**COMMENTS AND RESPONSE REPORT - DSR PHASE**

**Proposed “Aggeneis-Paulputs” 400kV Transmission Powerline & Substations Upgrades, Northern Cape Province  
DEA REF: 14/12/16/3/3/2/1012**

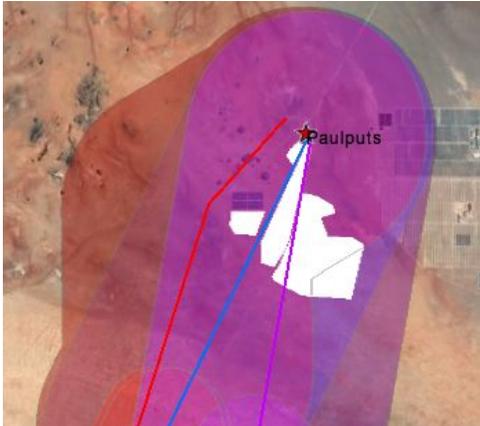
<p>AJA van Niekerk Family Trust Farm Aroams 57 RD</p> <p>E-mail: jhbprok@lantic.net</p> <p>Cell: 082 808 9132</p>	<p><b>Date: 23.08.16</b></p> <p>Main Street 957 (RF) Proprietary Limited(the “Project Company”), for the <b>Aggeneys Solar Energy Facility</b> (the “Project”),received a copy of the background information document (“BID”) and invitation to register and comment for the proposed Aggeneis – Paulputs 400kV Transmission Powerline on 16 August 2016 via email.</p> <p>The Project is located – 6KM north-east of Aggeneys town on portion 1 of the Farm Aroams 57 RD. The Project was awarded Preferred Bidder status under Round Four of the Renewable Energy Independent Power Producers Procurement Programme (REIPPPP) being implemented by the Department of Energy.</p>	<p><b>EAP:</b> The area of concern is illustrated in the map portion below (Full map is provided in Annexure C of the Scoping Report).</p> <p>The map shows that “Aggeneys Solar Energy Facility” (white area) is affected by approximately 0.6km of the 2km Corridor 2 (red corridor). Therefore, in order to avoid the development, Eskom would have to consider routing the powerline more towards the eastern section of the corridors, preferably within Corridor 1 (blue corridor). The final powerline route would require a servitude width of approximately 55m, which will not affect Aggeneys Solar Energy Facility.</p>

I&AP	Comments, Concerns & Queries	Response
	<p>After review the BID it was confirmed that proposed Routed 1 and 2, traverse over the project site. During engagements with Eskom regarding the Project, it was indicated that the EIA that had been completed for the new 220kV powerline avoided the Project. It was expected that upgrade EIA for the 400vV powerline route would follow this same route.</p> <p>During the EIA and design phase of the project, the Project Company has ensured that sufficient servitude areas associated with the Aggeneis/Gamsberg 66kV Powerline and the Aggeneis/Paulputs 220kV Powerline have been excluded from the Project site area. There has been no additional servitude considered for a new powerline on the Project site.</p> <p>The Project Company therefore objects to the proposed Routes 1 and 2 unless the Project site is completely avoided. As the Project is a Preferred Bidder Project and is targeted to commence with construction in the fourth quarter of 2016, there can be no adjustments to the Project site and therefore no new infrastructure can be permitted over the Project site.</p>

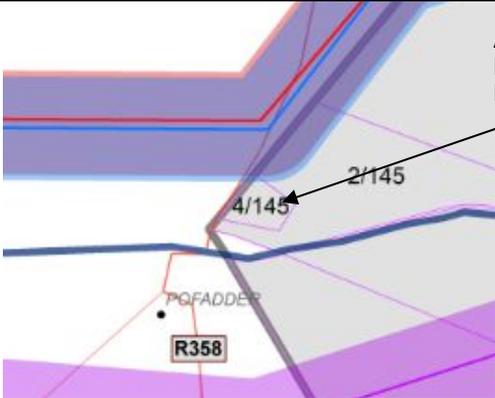
<p>Trustee: SF van Heever Farm Konkoonsies 91 E-mail: jhbprok@lantic.net Cell: 082 388 8396</p>	<p><b>Date: 23.08.16</b></p> <p>Ramizone (RF) Proprietary Limited (the “Project Company”), for the Konkoonsies II PV Solar Energy Facility ( the “Project”), received a copy of the background information document (“BID”) and invitation to register and comment for the proposed Aggeneis-Paulputs 400kV Transmission Power Line on 16 August 2016 via email.</p> <p>The Project is located – 30KM north-east of Pofadder town on portion 6 of the Farm Konkoonsies 91. The Project was awarded Preferred Bidder status under Round Four of the Renewable Energy Independent Power producers Procurement Programme</p>	<p><b>EAP:</b> The area of concern is illustrated in the map portion below (Full map is provided in Annexure C of the Scoping Report).</p> <p>The map shows that “Konkoonsies II PV Solar Energy Facility” (white area) is affected by the proposed corridors towards Paulputs substation.</p> <p>Please note that at the initial stage of the draft scoping phase the corridors close to Paulputs substation were 2km in width.</p> <p>Eskom had a meeting with the developers to discuss ways to avoid clashes with Konkoonsies II PV Solar Energy Facility. It was decided that the corridors towards Paulputs substation be</p>

I&AP	Comments, Concerns & Queries	Response
	<p>(REI PPP) being implemented by the Department of Energy.</p> <p>After reviewing the BID, it has been confirmed that all proposed route corridors traverse over the Project site (please refer to Annexure A). During the EIA and design phase of the Project, the Project Company ensured that sufficient servitude areas associated with existing Aggeneis/Paulputs 220kV powerline has been excluded from the Project site area.</p> <p>During discussions with Eskom regarding the Project’s grid connection, Eskom was advised by the Project Company that the Project was a Preferred Bidder Project and that the Project design had been approved. The Project Company, however, agreed to reserve as much servitude area along the existing Aggeneis/Paulputs 220kV powerline for the proposed powerline (at this point it was a new 220kV powerline). The Project Company managed to reserve 35m in addition to the existing servitude of 47m, therefore a total of 82m has been reserved along the existing Eskom servitude.</p> <p>The Project Company therefore objects to all of the proposed routes unless the Project site is completely avoided. As the Project is a Preferred Bidder Project and is targeted to commence with construction in the fourth quarter of 2016, there can be no further adjustments to the Project site.</p>	<p>expanded to 4km corridor width. This would allow more space within the corridor to avoid the proposed Solar developments close to Paulputs.</p>  <p><b>Eskom:</b> Eskom met with Biotherm Energy Pty (Ltd) on 14 December 2016 to discuss the possible alternative line routes around the Project Site as there were space constraints with the proposed 2km wide corridors. It was agreed that the corridors toward the Project Site be widened to 4km in order to allow for more options in effecting a line route to be finalised, depending on the corridor to be authorised by the Department of Environmental Affairs.</p>
